PRODUCT CHANGE NOTIFICATION (PCN)

A-MCUP-80050 MODULAR CABLE

PCN 20220425_A-MCUP-80050

A-MCUP-80050		OLD VERSION		A-MCUP-80050		NEW VERSION																																	
Apprearence				Apprearence

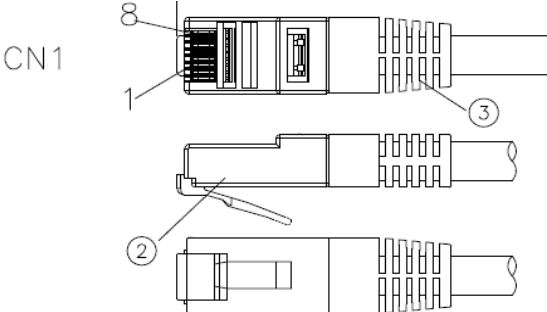
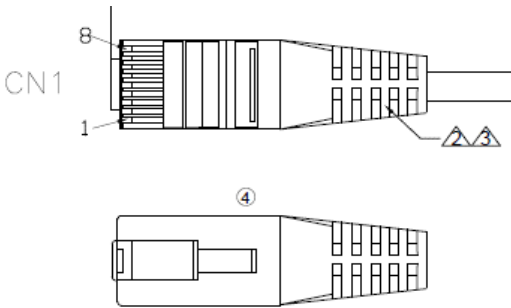
BOM				BOM																																			
<table><tr><td>③</td><td>Molding PVC</td><td>2</td><td>Molding PVC 45P</td></tr><tr><td>②</td><td>RJ45 CONN</td><td>2</td><td>RJ45 8P8C,Two Fork gold plated contacts 3u" gold</td></tr><tr><td>①</td><td>CABLE</td><td>1</td><td>UTP(26AWG*x1PR)*4+PVC OD:4.9±0.2mm</td></tr><tr><td>NO.</td><td>NAME.</td><td>Q'TY</td><td>SPECIFICATION</td></tr></table>				③	Molding PVC	2	Molding PVC 45P	②	RJ45 CONN	2	RJ45 8P8C,Two Fork gold plated contacts 3u" gold	①	CABLE	1	UTP(26AWG*x1PR)*4+PVC OD:4.9±0.2mm	NO.	NAME.	Q'TY	SPECIFICATION	<table><tr><td>④</td><td> Molding PVC</td><td>2</td><td>Molding PVC 65P</td></tr><tr><td>④</td><td> RJ45 CONN</td><td>2</td><td>RJ45 8P8C, contacts 3u" gold-plated Un-shielded PC UL94V-2</td></tr><tr><td>④</td><td> CABLE</td><td>1</td><td>CAT 5E U/UTP(26AWGx1PR)*4+PVC Jacket OD:4.9±0.2mm</td></tr><tr><td>NO.</td><td>NAME.</td><td>Q'TY</td><td>SPECIFICATION</td></tr></table>				④	 Molding PVC	2	Molding PVC 65P	④	 RJ45 CONN	2	RJ45 8P8C, contacts 3u" gold-plated Un-shielded PC UL94V-2	④	 CABLE	1	CAT 5E U/UTP(26AWGx1PR)*4+PVC Jacket OD:4.9±0.2mm	NO.	NAME.	Q'TY	SPECIFICATION

③	Molding PVC	2	Molding PVC 45P																																				
②	RJ45 CONN	2	RJ45 8P8C,Two Fork gold plated contacts 3u" gold																																				
①	CABLE	1	UTP(26AWG*x1PR)*4+PVC OD:4.9±0.2mm																																				
NO.	NAME.	Q'TY	SPECIFICATION																																				
④	 Molding PVC	2	Molding PVC 65P																																				
④	 RJ45 CONN	2	RJ45 8P8C, contacts 3u" gold-plated Un-shielded PC UL94V-2																																				
④	 CABLE	1	CAT 5E U/UTP(26AWGx1PR)*4+PVC Jacket OD:4.9±0.2mm																																				
NO.	NAME.	Q'TY	SPECIFICATION																																				
FOR DETAIL, PLEASE TAKE ATTACHED NEW DRAWING: FOR REFERENCE
